Re: French-American School of New York ("FASNY") v. Mayor Thomas Roach and the  
Common Council of the City of White Plains  
Supreme Court of the State of New York, Westchester County  
Index Number: 2067/2015  
Hon. Joan B. Lefkowitz

The following is my report on the Revised Plan that the French American School of New York (FASNY) has submitted to the Common Council for approval including: Special Permit and Site Plan approval Letter, Oct 31, 2016, Full Environmental Assessment Form, Oct 31<sup>st</sup> 2016, Environmental Analysis, AKRF, Oct 31 2016 and Amended Transportation Management Plan, AKRF, 2016. I have also reviewed and reported on prior submissions by FASNY including the December 2013 Findings. The City of White Plains has had previous submittals reviewed by a third party traffic engineer. I have not seen the third party review for this October submission. I have a Bachelor of Science in Civil Engineering and 30 years of experience in the industry. My curriculum vitae are previously included in the record.

# Appendix A

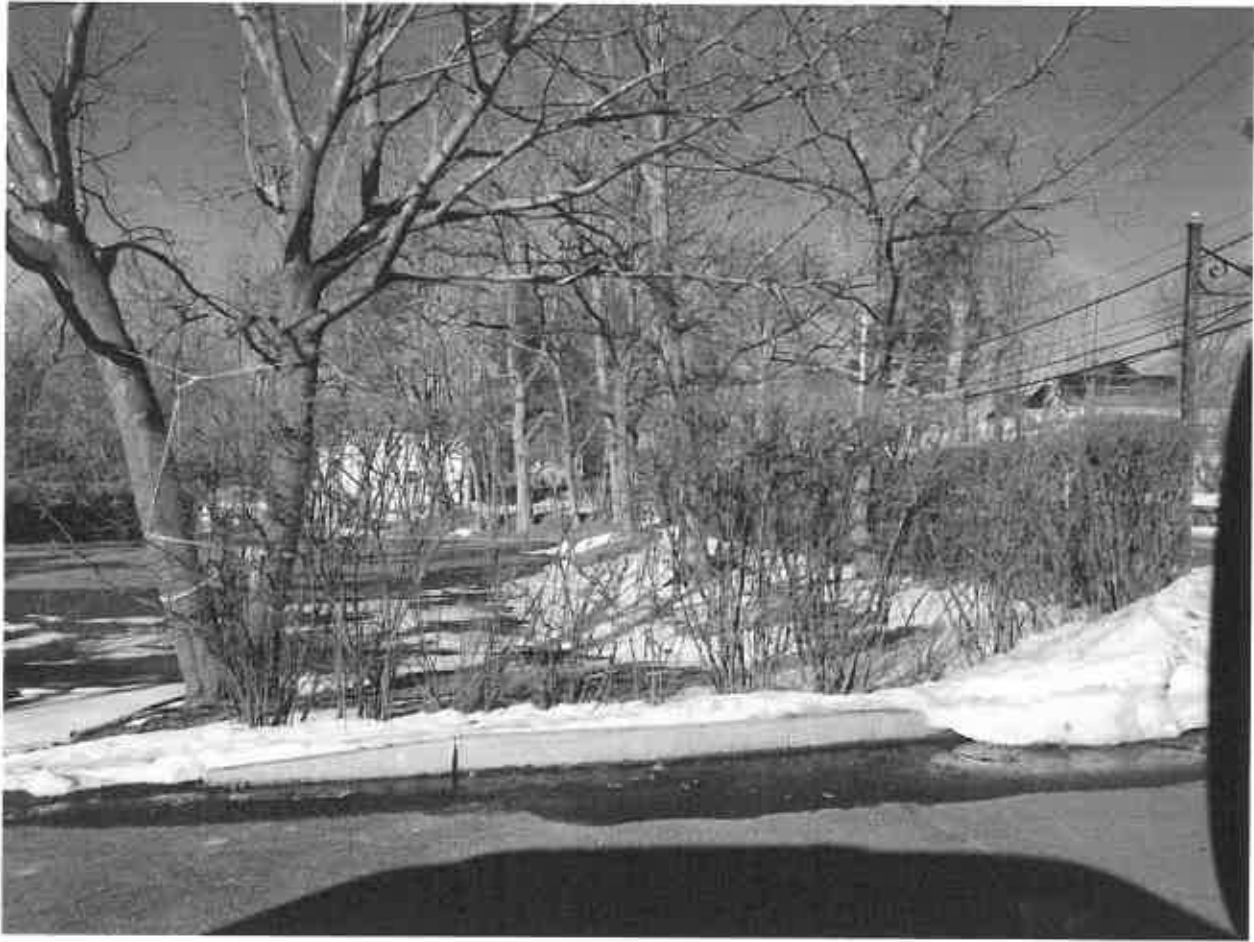
**Safety Impacts at Ridgeway and Hathaway Lane** – The increase in traffic volume associated with the Plan presents substantial public safety risks to vehicular, bicycle and pedestrian traffic. There is insufficient intersection sight distance at the Hathaway Lane and Ridgeway intersection. (Intersection sight distance means the ability to see right or left when pulling out of Hathaway onto Ridgeway). A vehicle stopped at the stop sign/stop line southbound on Hathaway Lane cannot see to the right or left to pull out into traffic on Ridgeway. Rather, traffic must stop at the stop line/sign and then pull up again to obtain a view of traffic on Ridgeway. This lack of adequate sight distance is significant for the anticipated large increase of traffic that will need to use Hathaway Lane to access Ridgeway. Several of these drivers will be of High School age. The additional start-stop maneuver on Hathaway Lane causes further delay than reported and a heightened potential for rear end collisions. Further, the stopping sight distance along Ridgeway (vehicles travelling on Ridgeway but not seeing vehicle stopped on Ridgeway waiting to turn onto Hathaway) was not addressed in the revised analysis. See Photos in Appendix A.

**Diversion of Existing Hathaway Lane traffic** – The substantial increase in volume at Hathaway Lane and Ridgeway will likely cause diversion of traffic from Hathaway lane south of Gedney Esplanade to other local streets including Gedney Esplanade, Hotel Drive and Murchison Avenue. Traffic generated on weekends by guests of vendors renting the FASNY facility can also choose to travel these neighborhood streets. Gedney Esplanade, Hotel Drive and Murchison Place will be impacted by increased traffic volumes. The roads are narrow with cars often parking on the street and thus cars bypassing Hathaway Lane will result in conditions that will make accommodating two-way traffic difficult and therefore unsafe for pedestrians and bicyclists. Given the narrowness and curves it is not desirable for safety reasons to add additional traffic. The intersection of Hotel Drive and Gedney Esplanade has restricted sight lines for turning vehicles. There is also a cross walk at the Ridgeway and Murchison Place intersection. See photos in Appendix A.
